IDAHO DEPARTMENT OF WATER RESOURCES
RECOMMENDATION OF WATER RIGHTS ACQUIRED UNDER STATE LAW

RIGHT NUMBER: 63-9804
NAME AND ADDRESS: STATE OF IDAHO
DEPT OF LANDS
300 N 6TH ST STE 103
PO BOX 83720
BOISE ID 83720-0050

IDL 61 & 63 Late claims update

63-9804 issue with spring #1

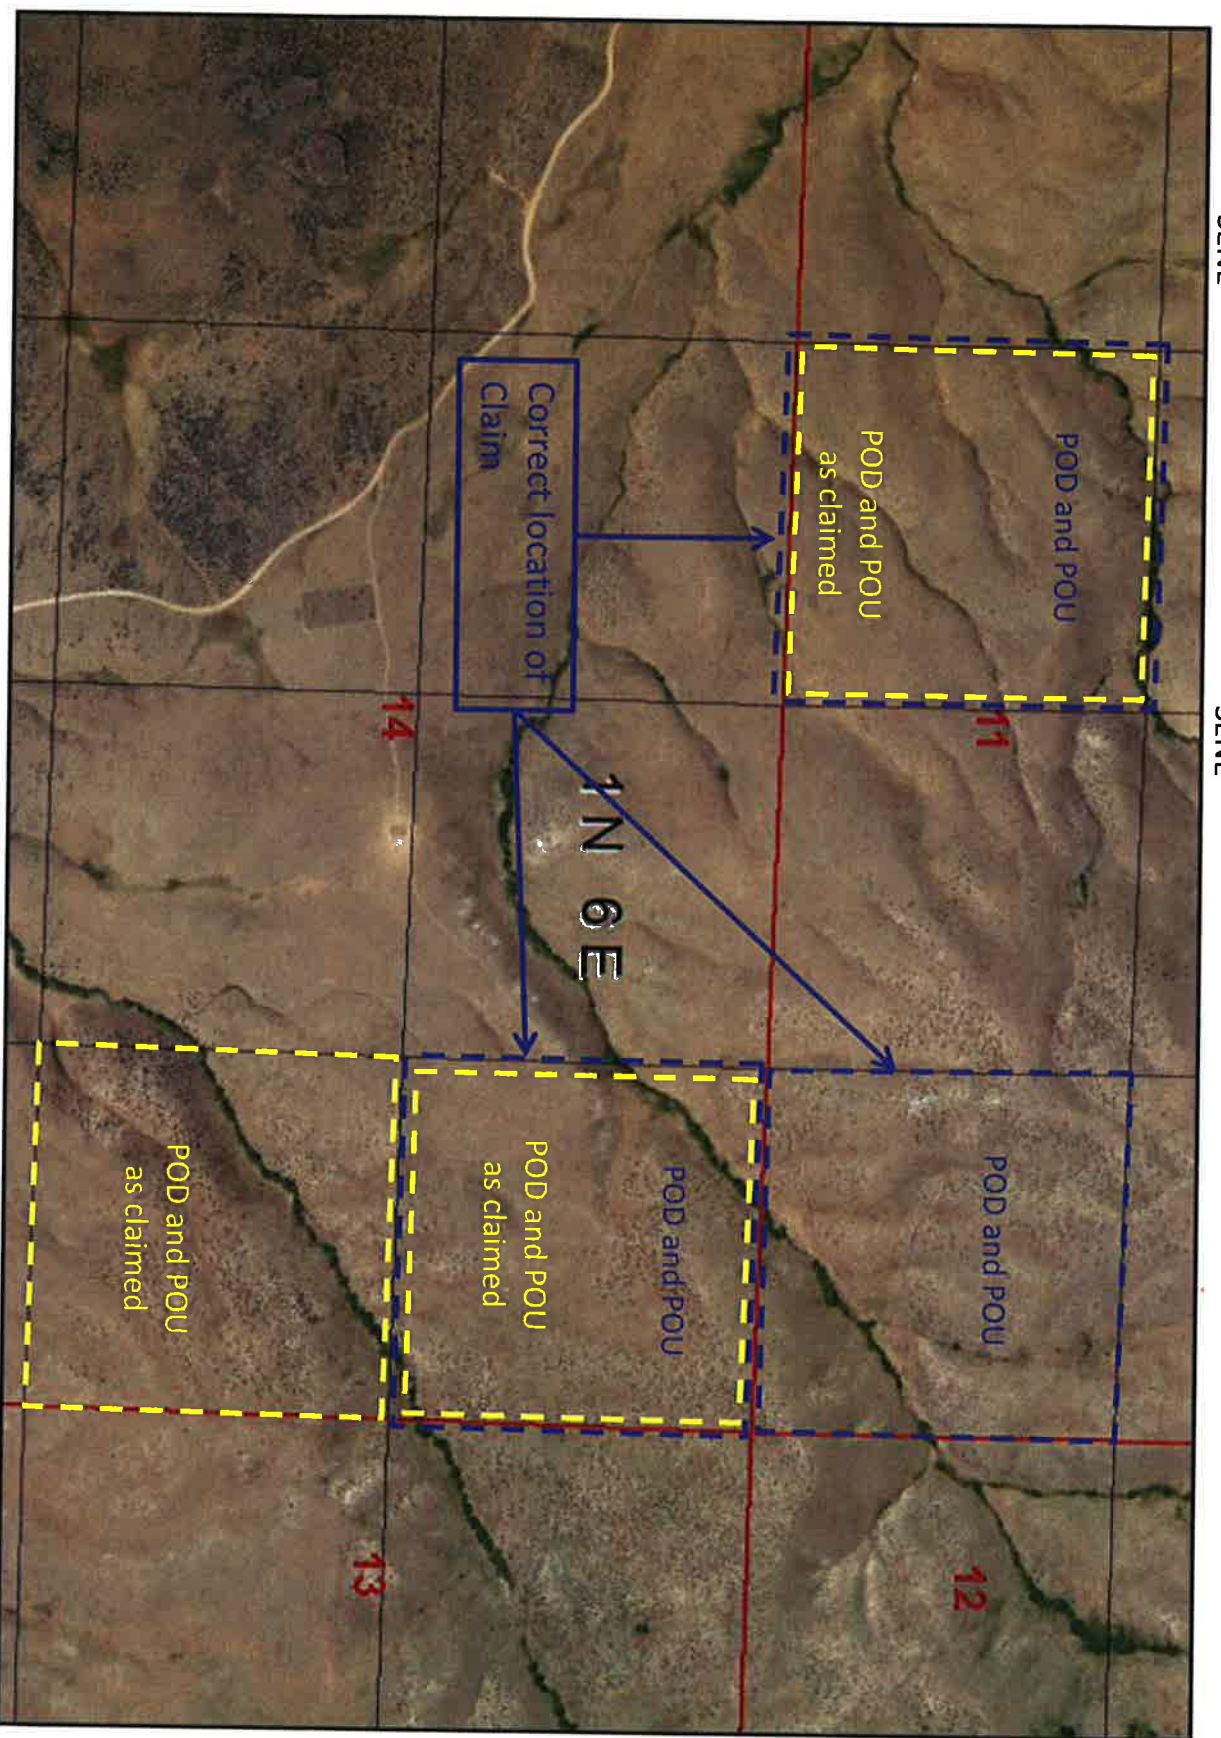
ACTUAL
SITE
POD/POU

Claimed

POD: T01N, R06E, S11, SESW
S14, NENE
SENE

POU: T01N, R06E, S11, SESW
S14, NENE
SENE

63-09804

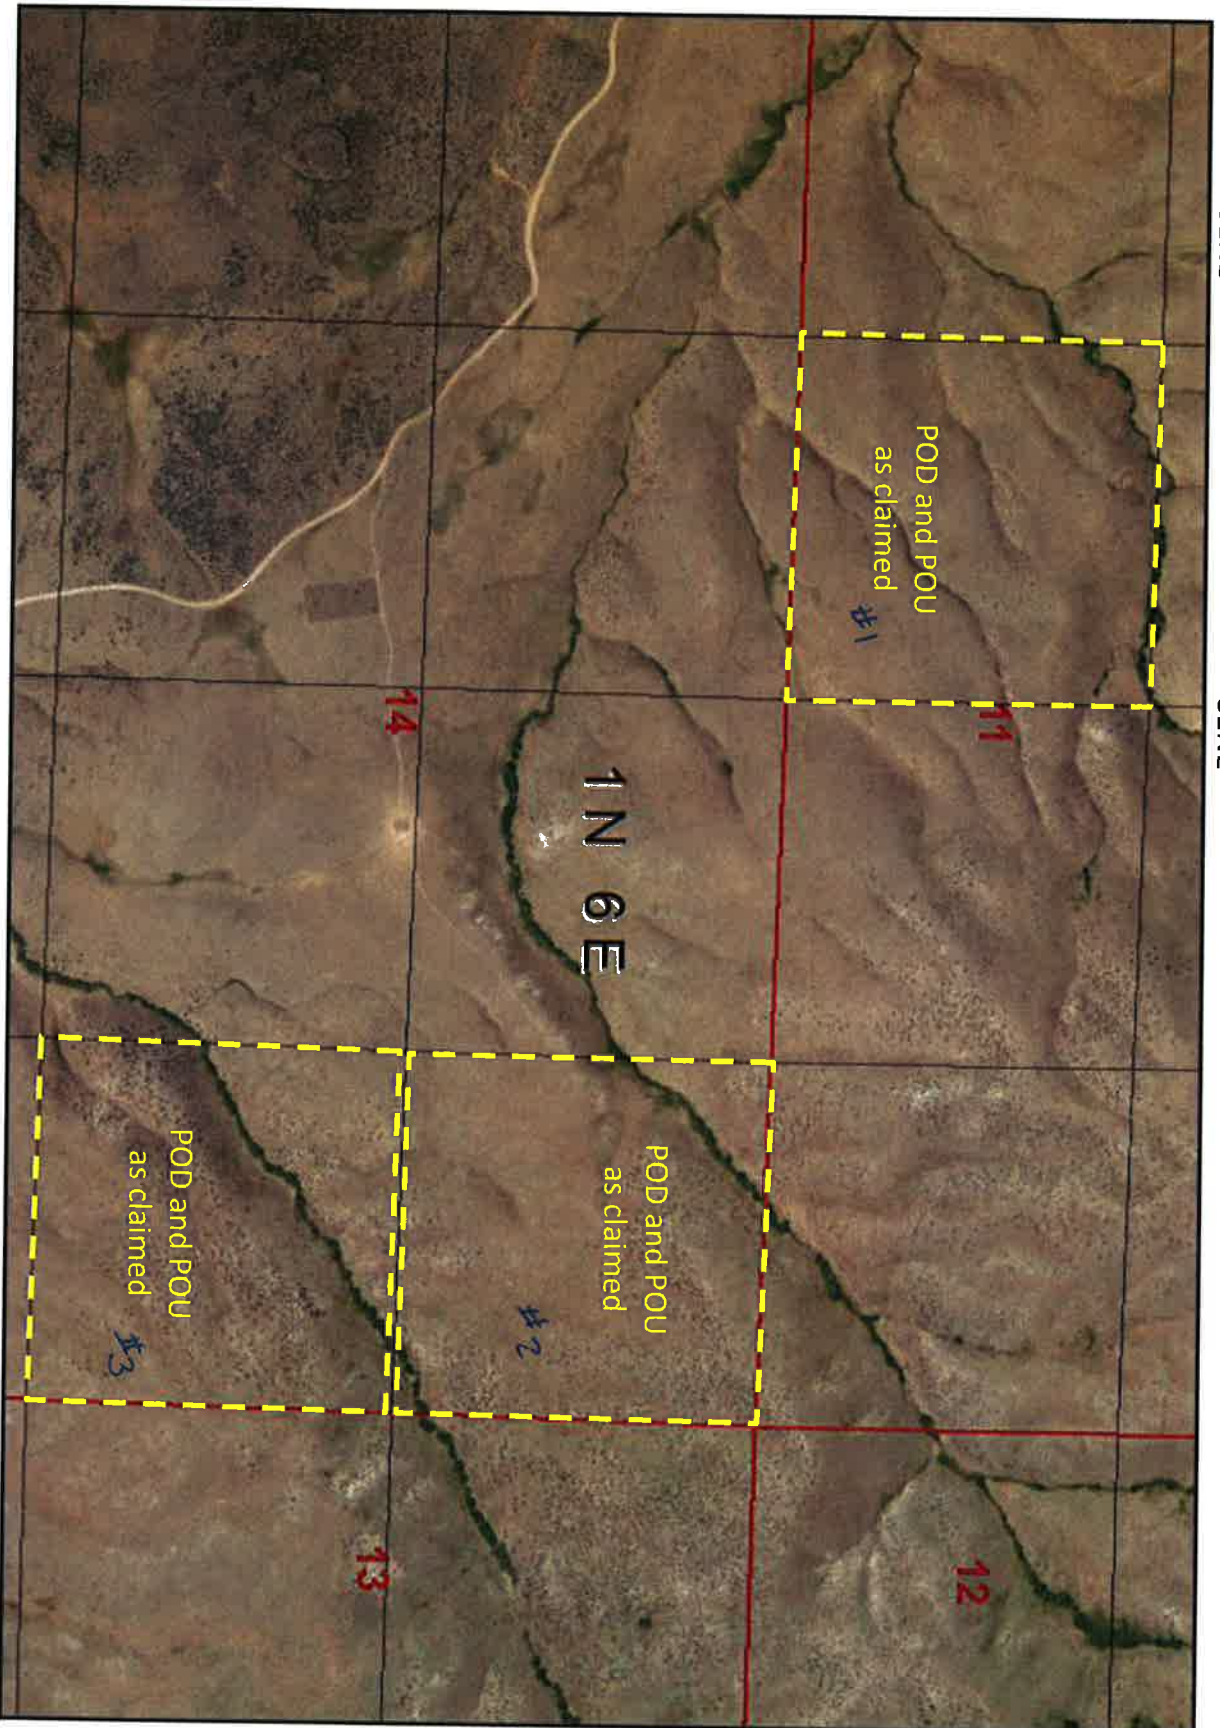
If the claimed POD and POU described in S14, SESE is actually located in S14, NENE, and the claimed POD and POU described in S14, NENE is actually located in S11, SESE, then the only amendment that needs to be made to this claim would be to change the POD and POU legal descriptions of T01N, R06E, S14, SENE to T01N, R06E, S11, SESE.

#1

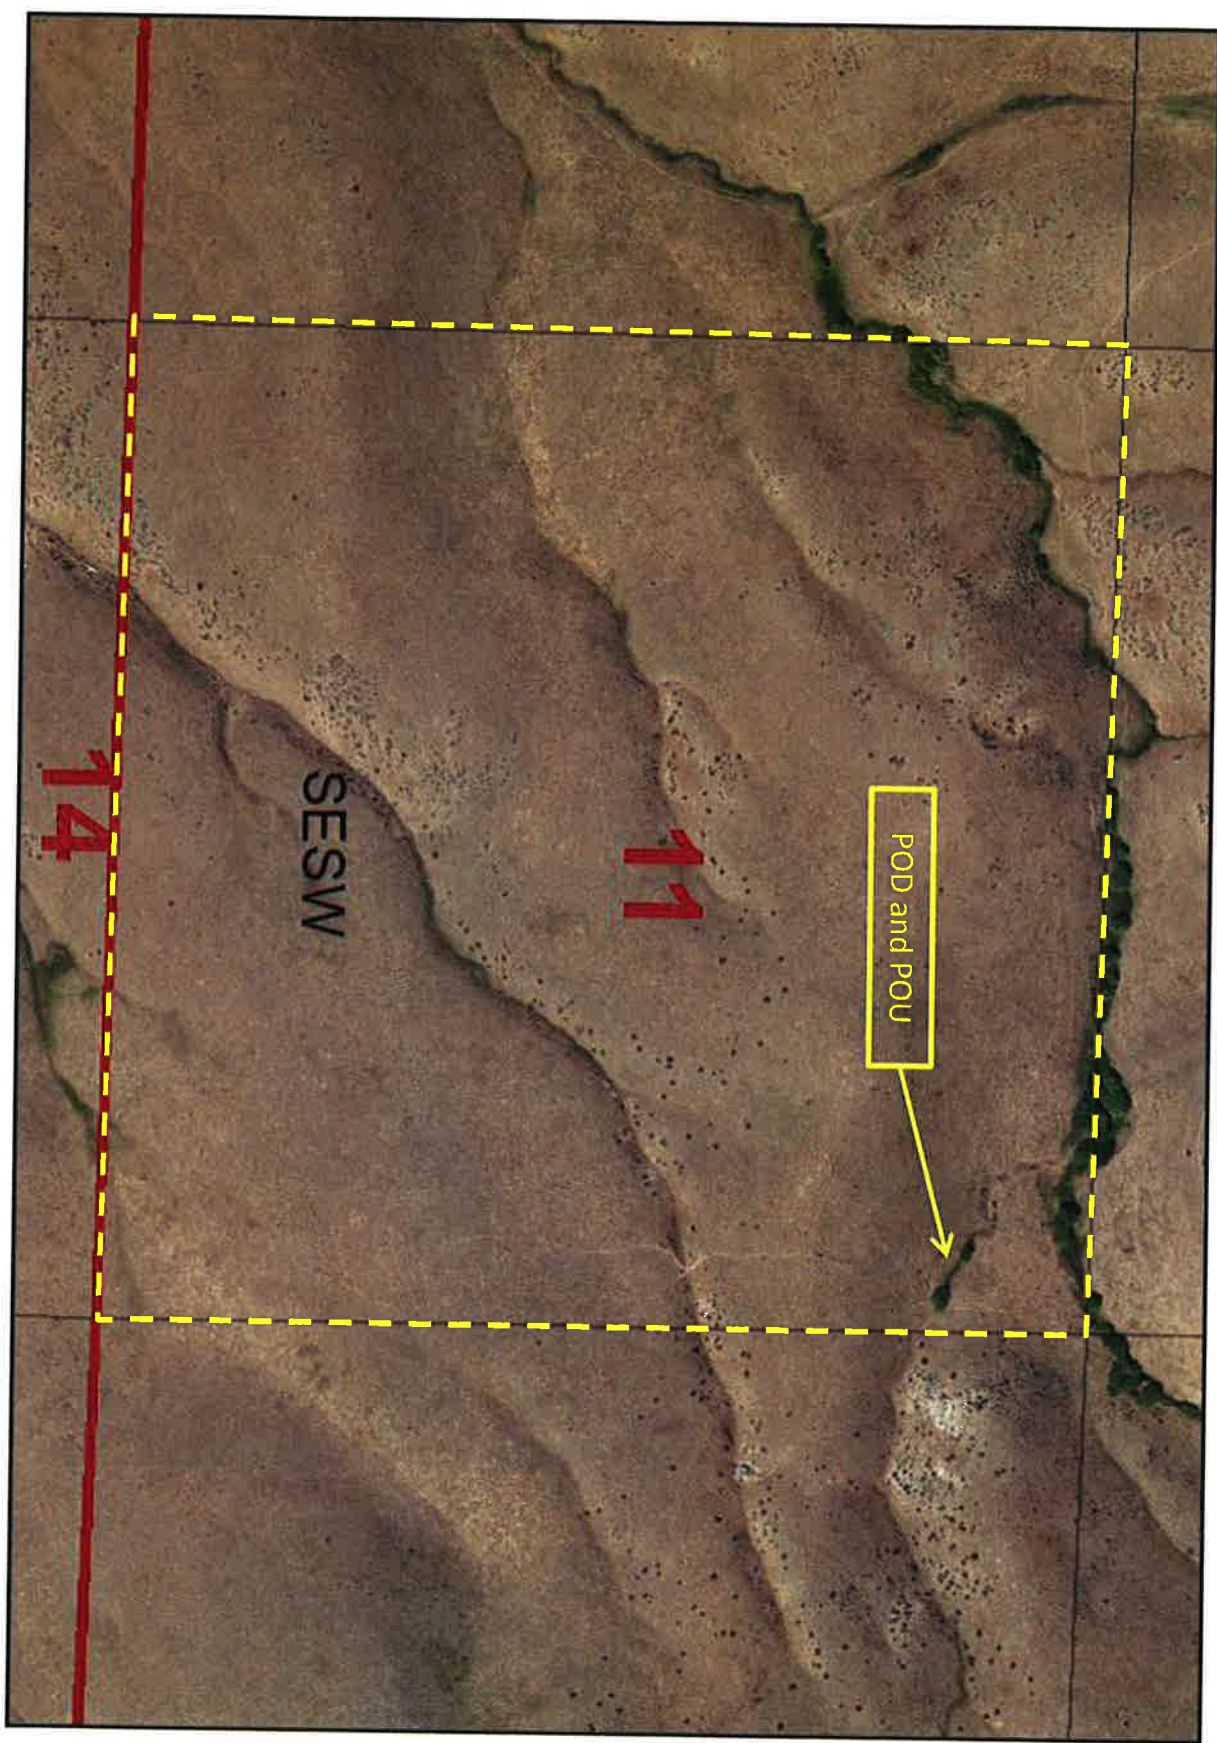
This portion of the claim is correct.

#2

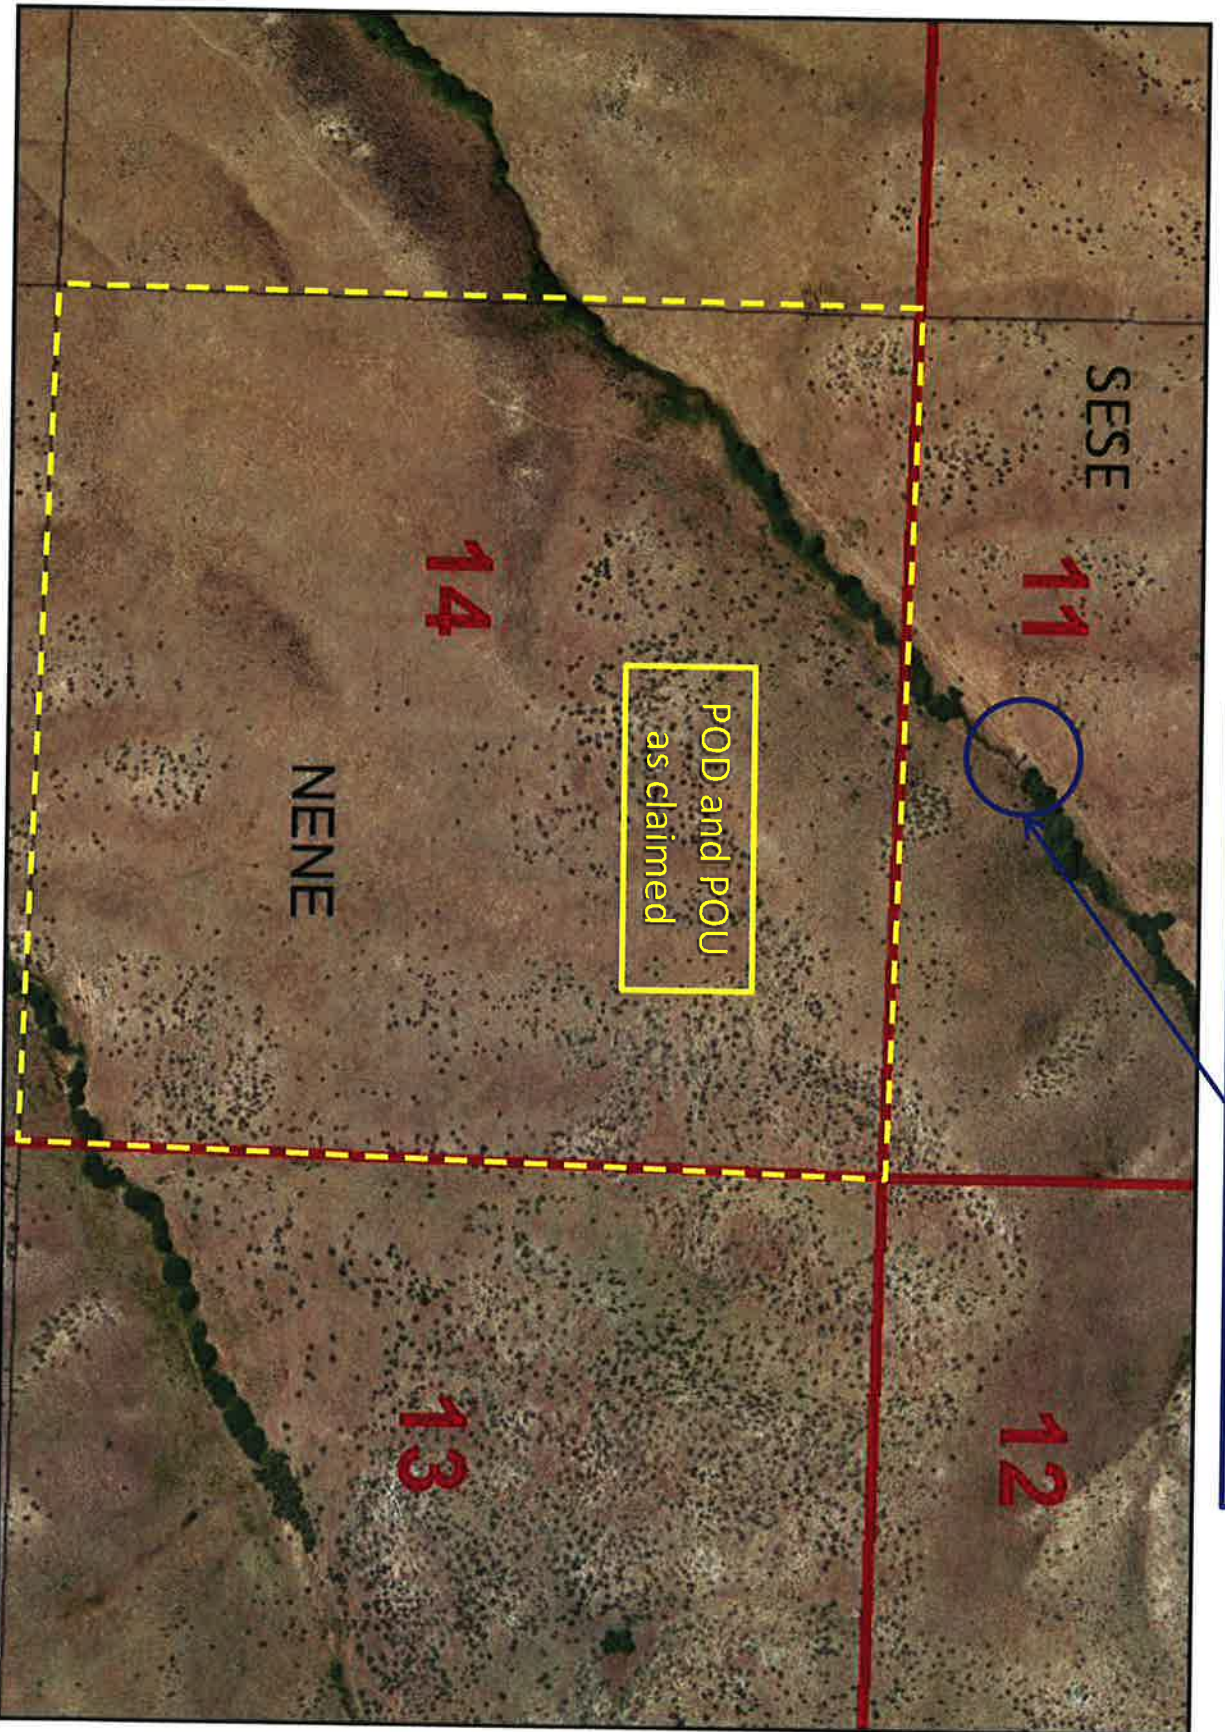
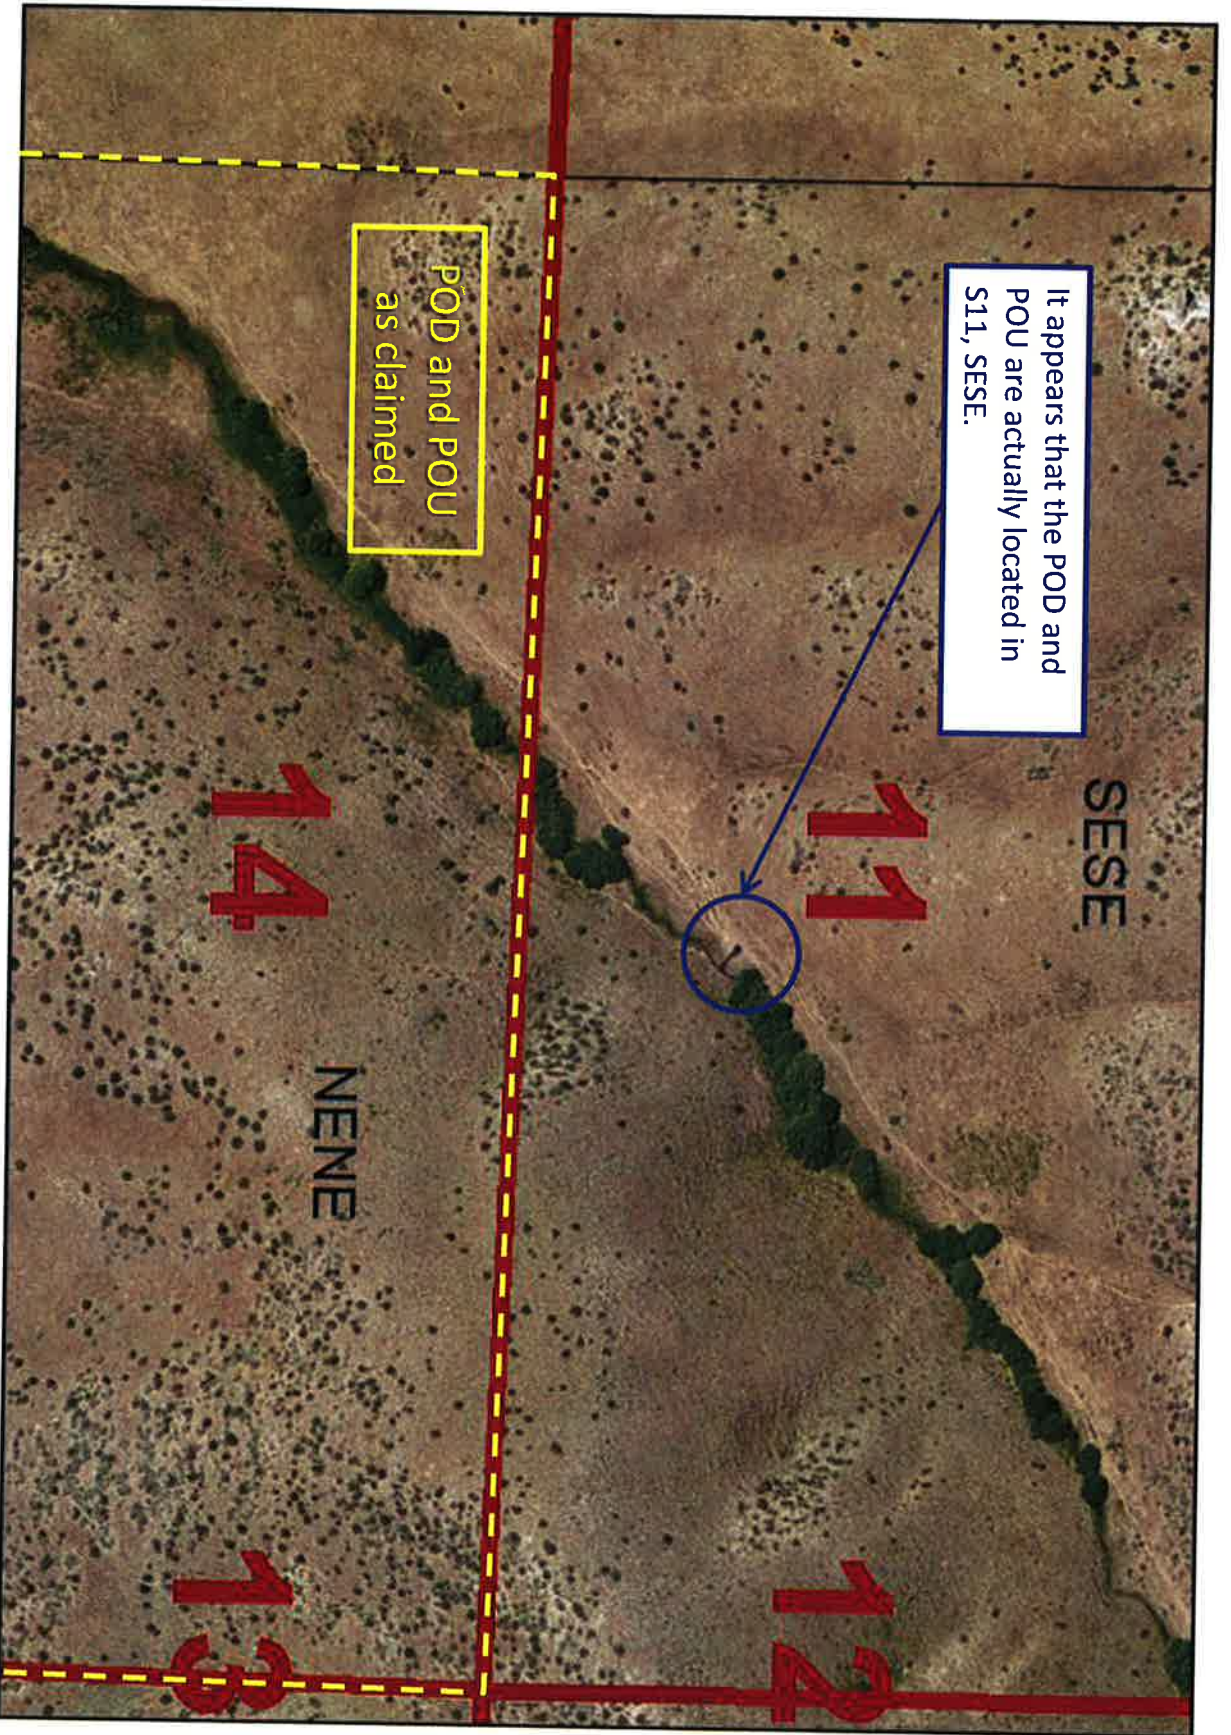
It appears that the POD and POU are actually located in S11, SESE. See blow up on next page.
